GAFFNEY BOARD OF PUBLIC WORKS

I-85 SEWER EXTENSION  
CONTRACT 1C – COLLECTIONS

ADDENDUM NO. 6

January 10, 2024

S-01-101A

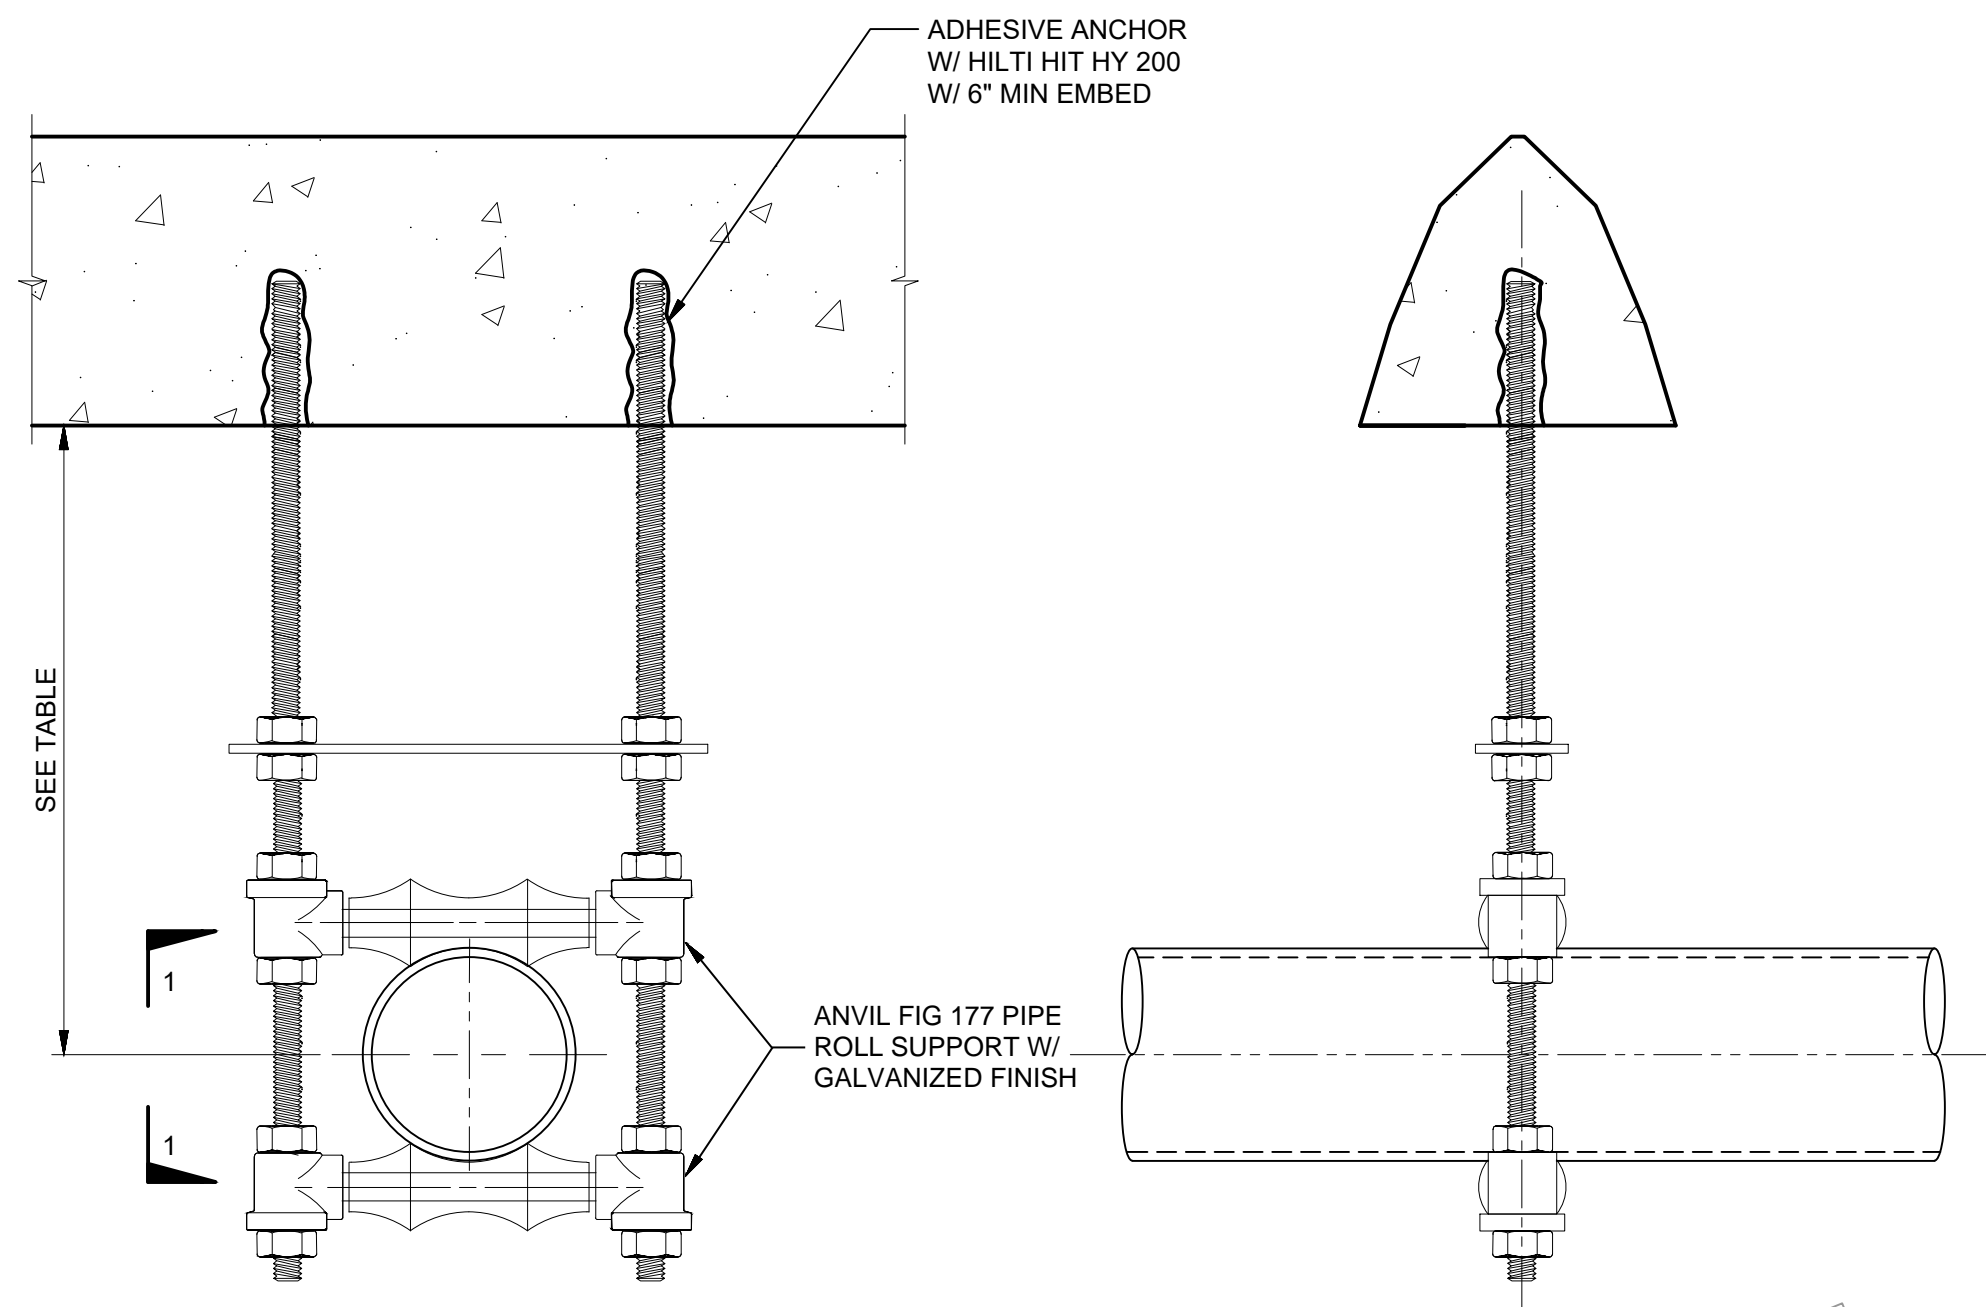
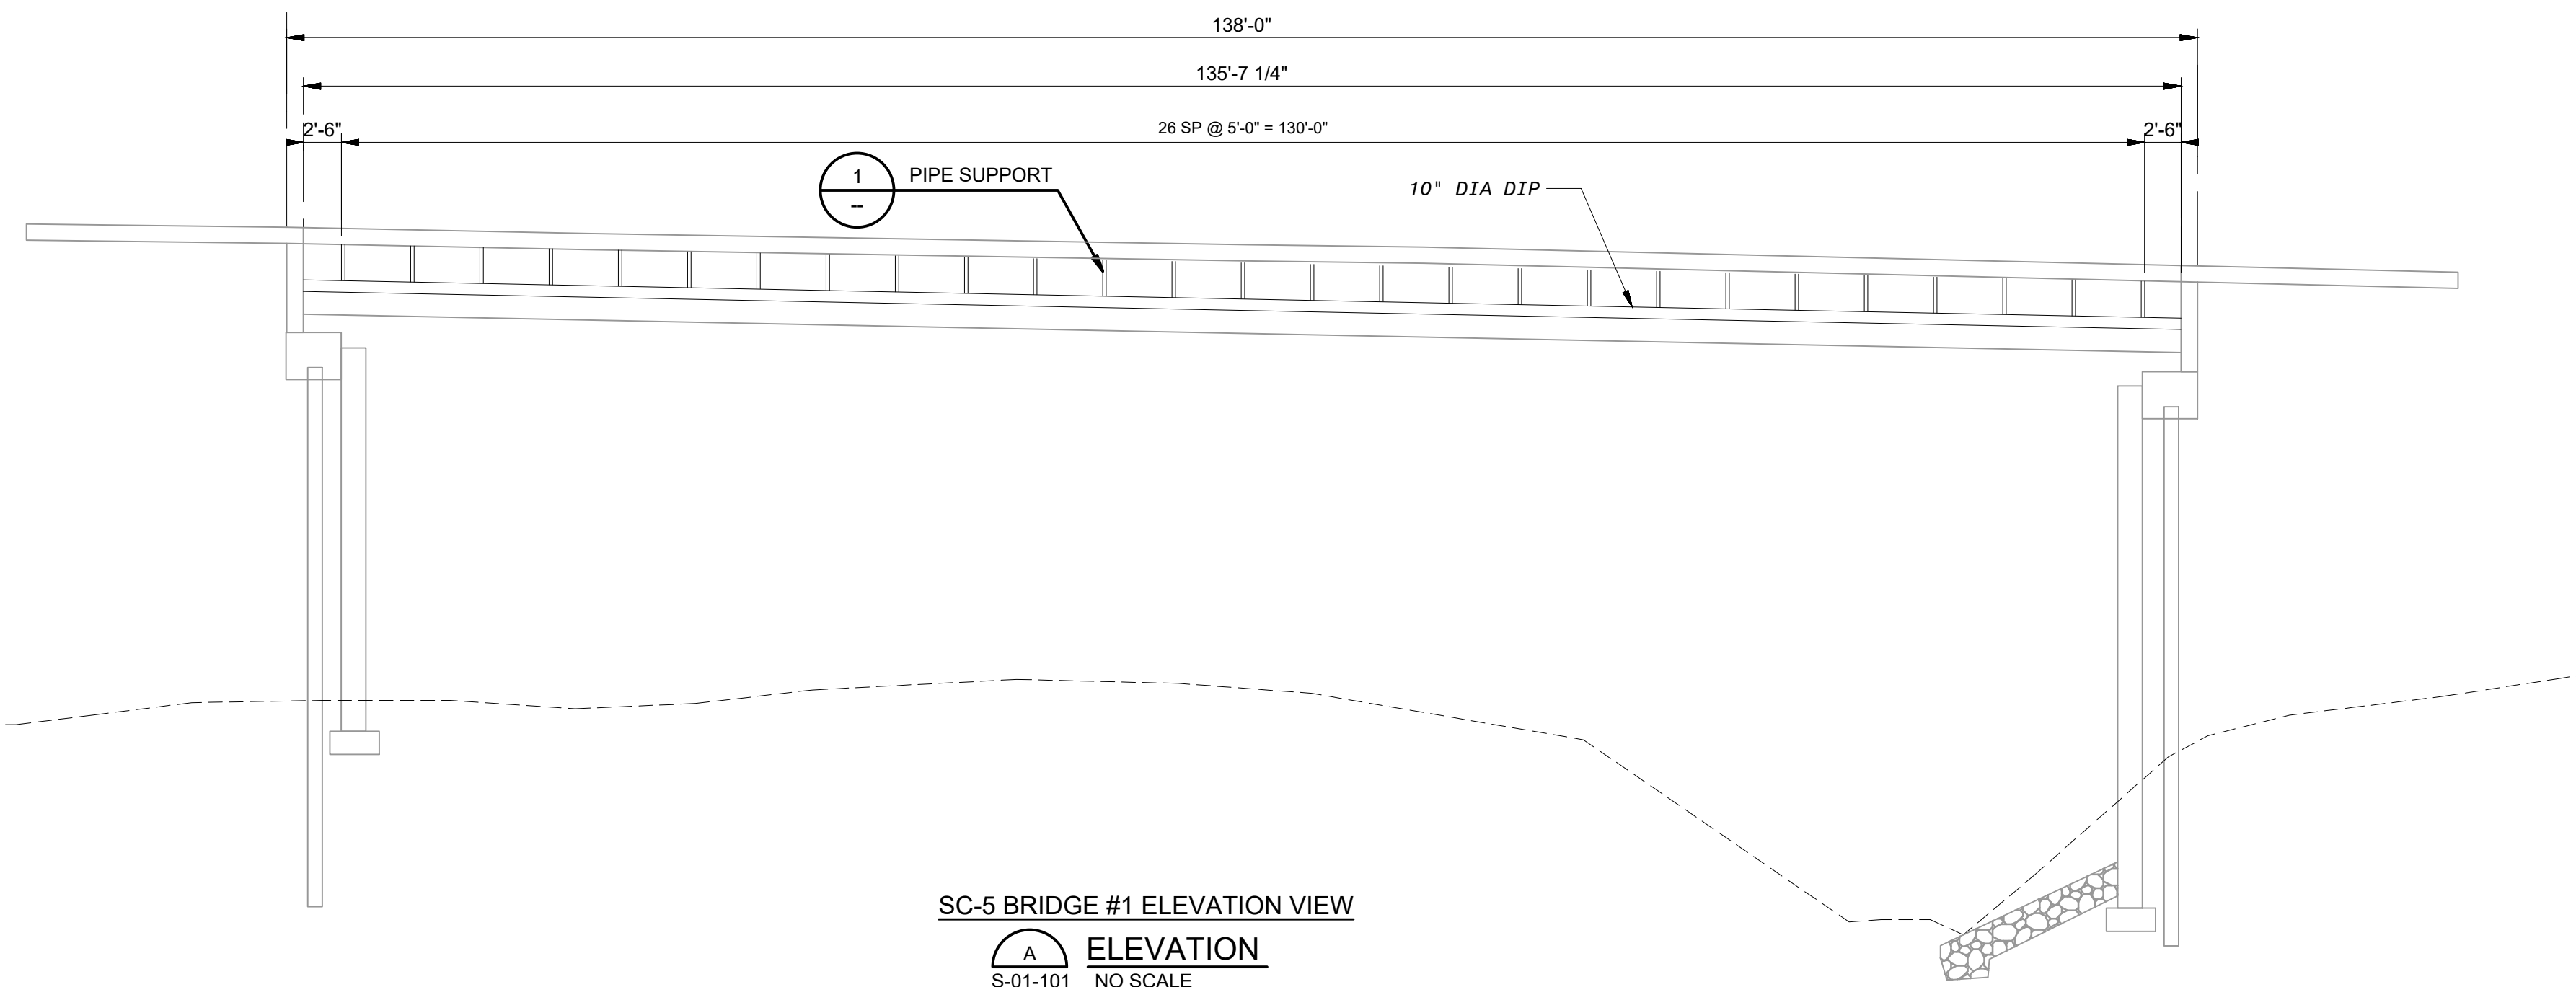
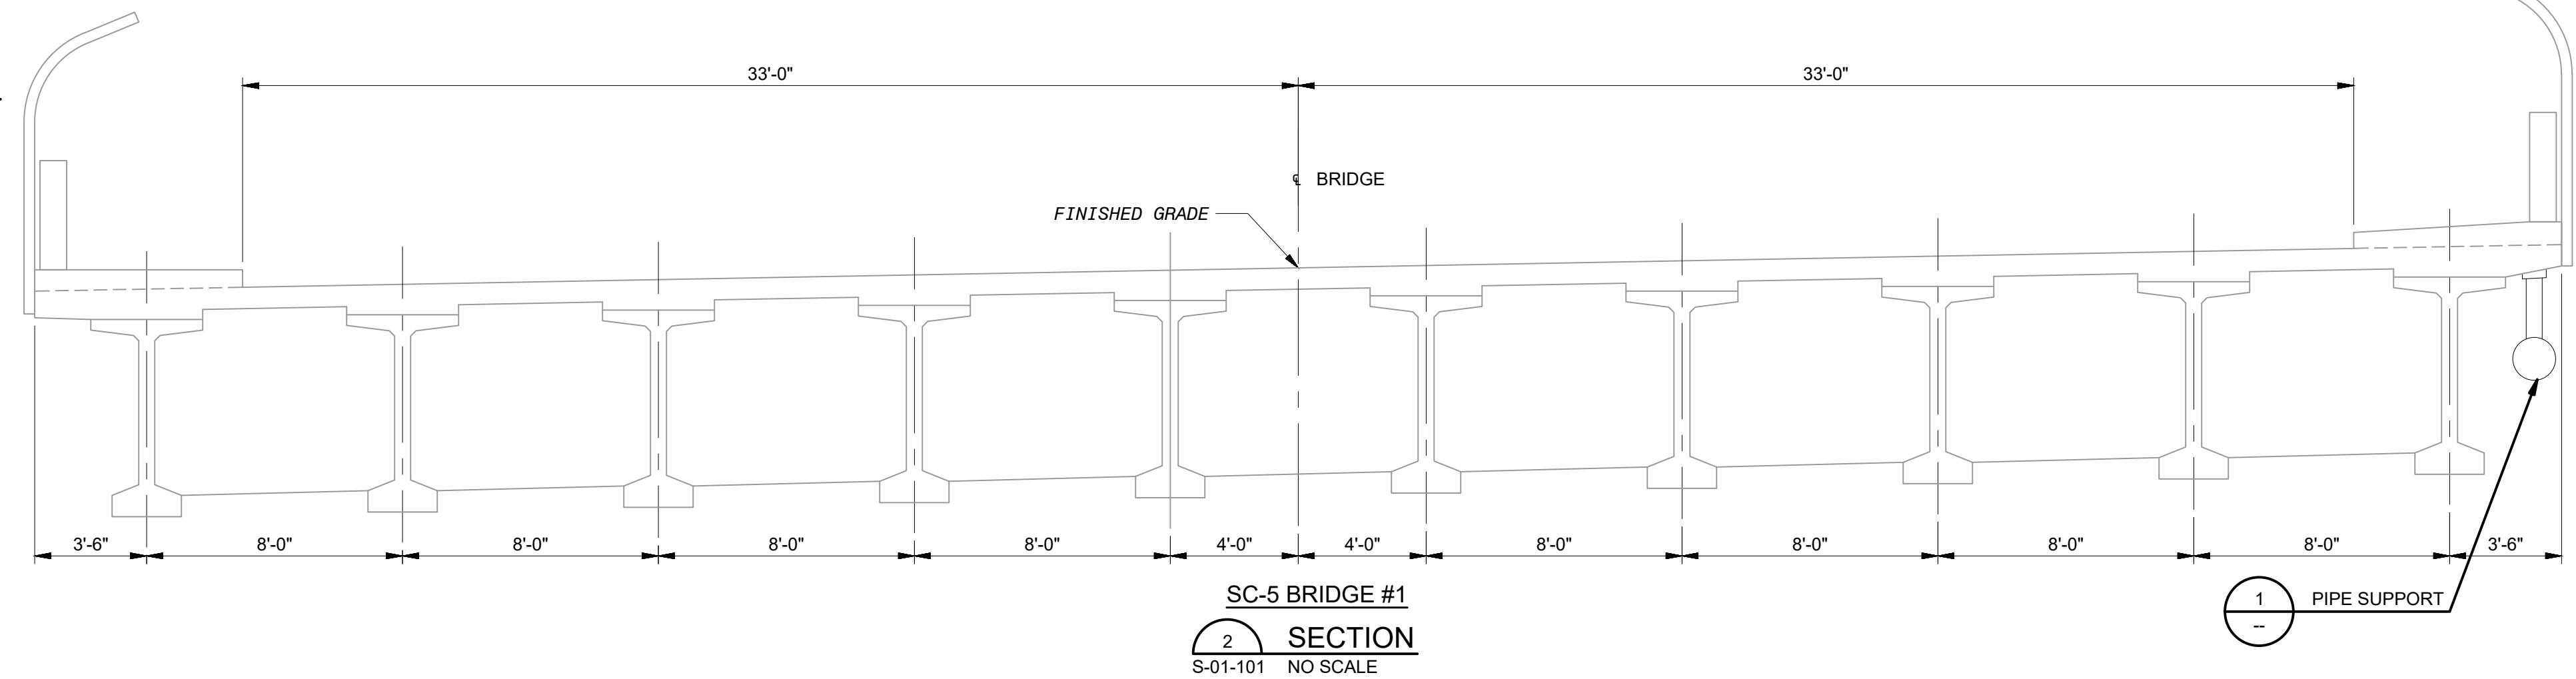
- i. Insert the attached new sheets C-06-103A and C-06-104A for Segment 6 Alternative 1 and the new sheet C-08-102A for Segment 8 Alternative 2 after sheet C-16-109.
- ii. Insert the attached new sheets S-00-001, S-01-101A, and S-01-102A for the Alternatives after sheet C-99-006.
